Subject: Permit Modification Request for **Nationwide Permit 23, 401 Water Quality Certification, and Tar-Pamlico Riparian Buffer Authorization Request** for the proposed replacement of Bridge Nos. 127 over the Tar River Overflow and 129 over the Tar River on SR 1565 in Pitt County. TIP No. B-3684; Federal Aid Project No. BRSTP-1565(4); State Project No. 8.2221101. Debit \$475 from WBS No. 33225.1.1

**NCDOT**  
 DIVISION OF HIGHWAYS  
 PITT COUNTY  
 PROJECT 333225.1.1.0 (B-3684)  
 BRIDGES NO. 129 OVER TAR RIVER  
 AND BRIDGE NO. 127 OVER TAR RIVER  
 OVERFLOW ON SR 1565

Permit Drawing  
Sheet 6 of 35  
REV. 8-3-09

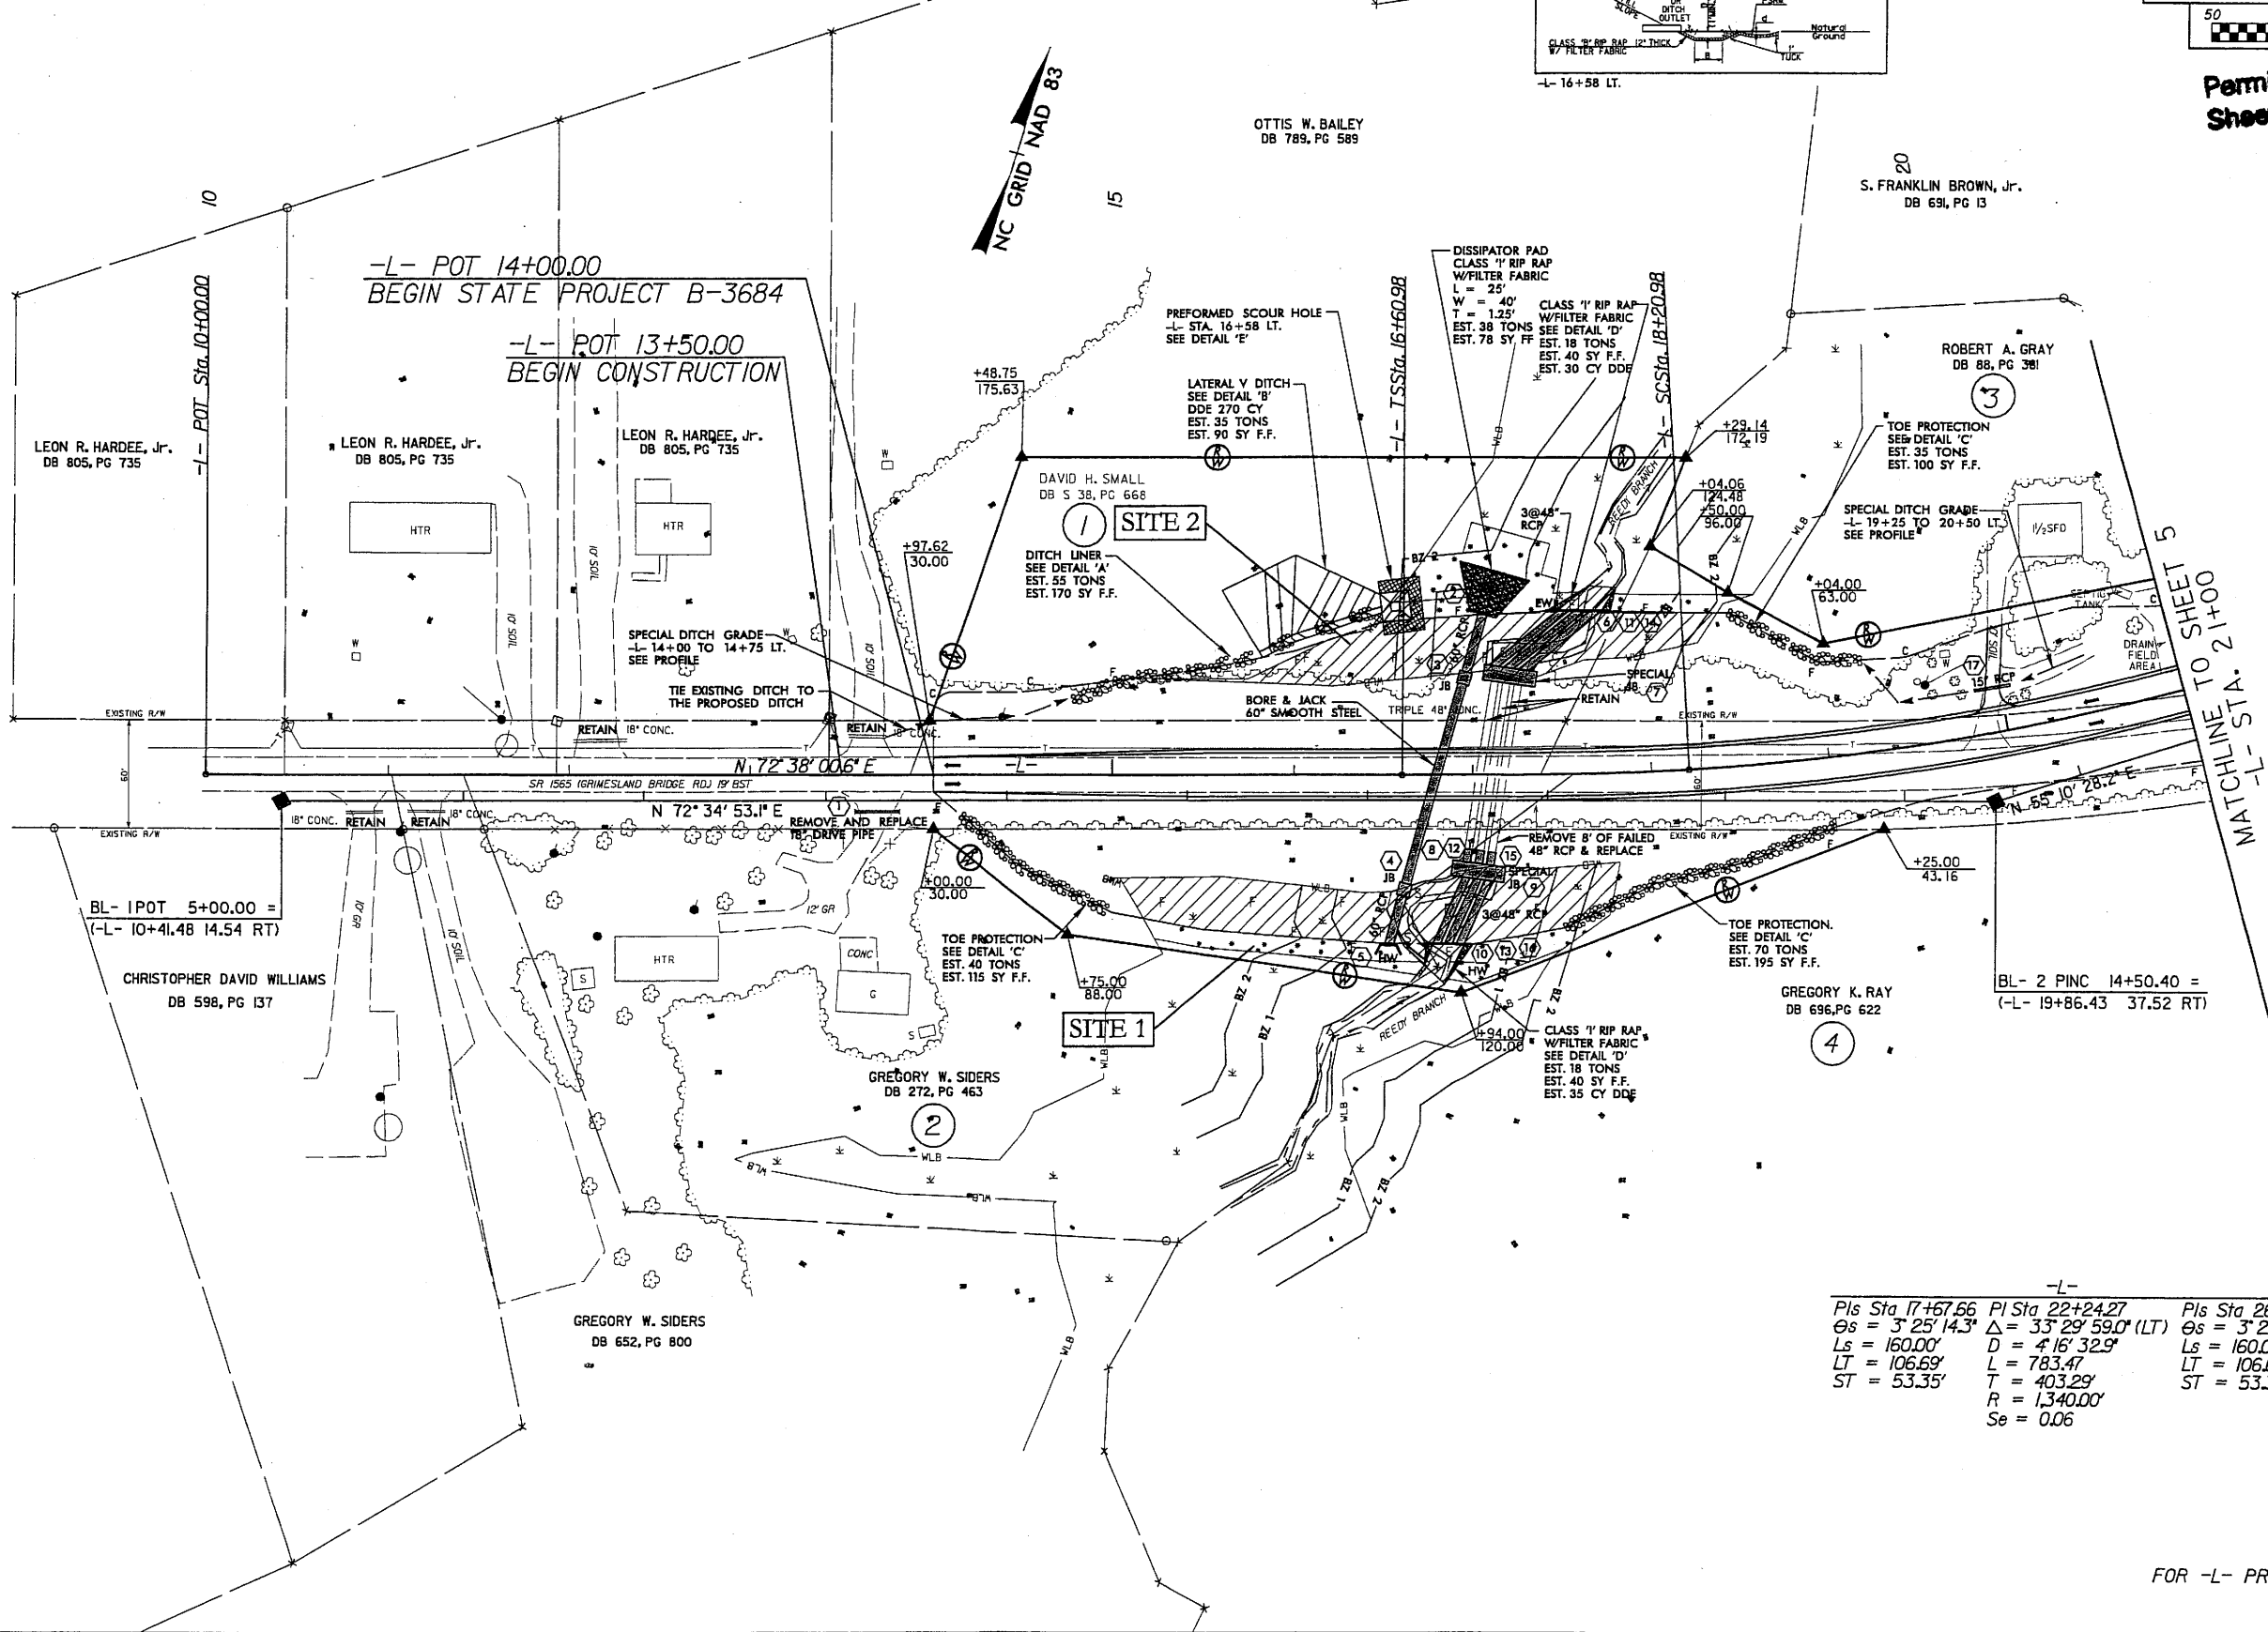
Please see the enclosed revised permit drawings, buffer drawings, and the revised debit ledger for the Grimesland Bridge Mitigation site for the above referenced project. During construction, additional riparian wetland impacts (0.08 acre permanent riparian wetland impacts) in the form of mechanized clearing were required at Sites 1 and 2. In addition, 2,704 ft<sup>2</sup> of impacts to riparian buffers were necessary to facilitate construction.

PROJECT REFERENCE NO. B-3684	SHEET NO. 5
RAW SHEET NO.	
ROADWAY DESIGN ENGINEER	HYDRAULICS ENGINEER
<b>Buffer Drawing</b> <b>Sheet 7 of 9</b> REV. 8-3-09

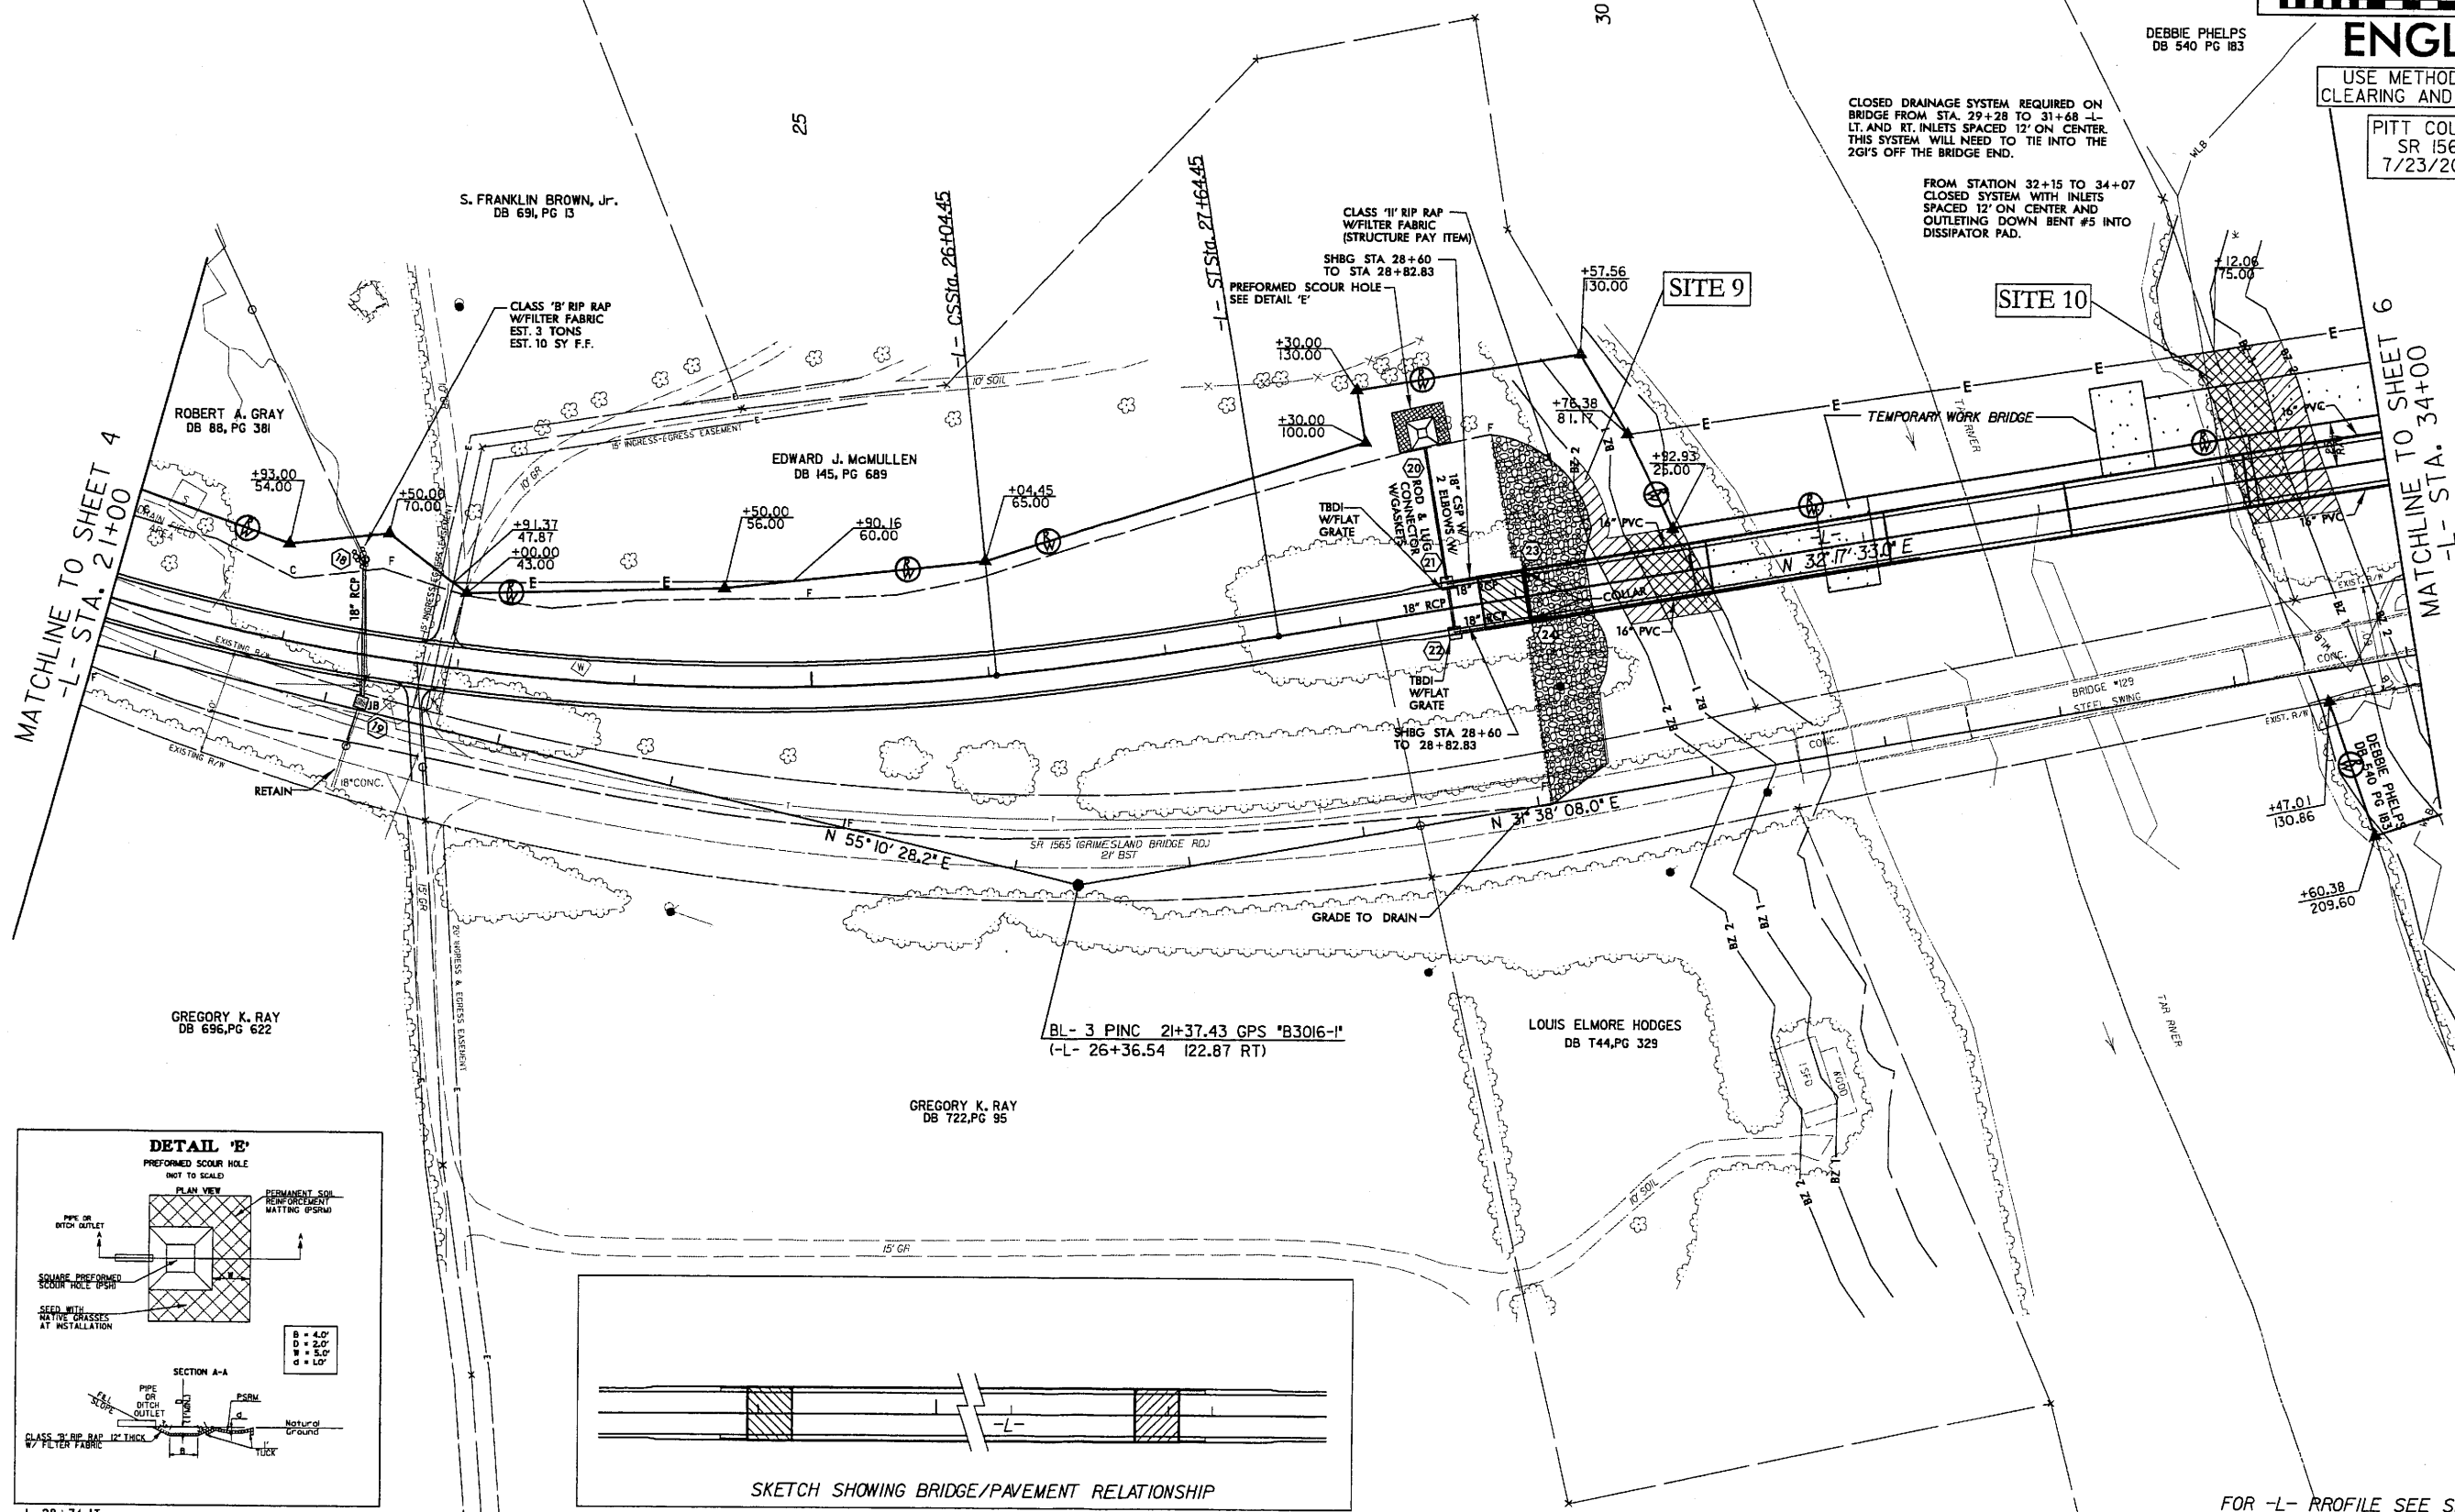
12-07-07 R/W REVISION ADJUSTED EASEMENT TO PARCEL NO.7 DUE TO PERMIT DRAWING IN THE GRIMESLAND MITIGATION SITE.
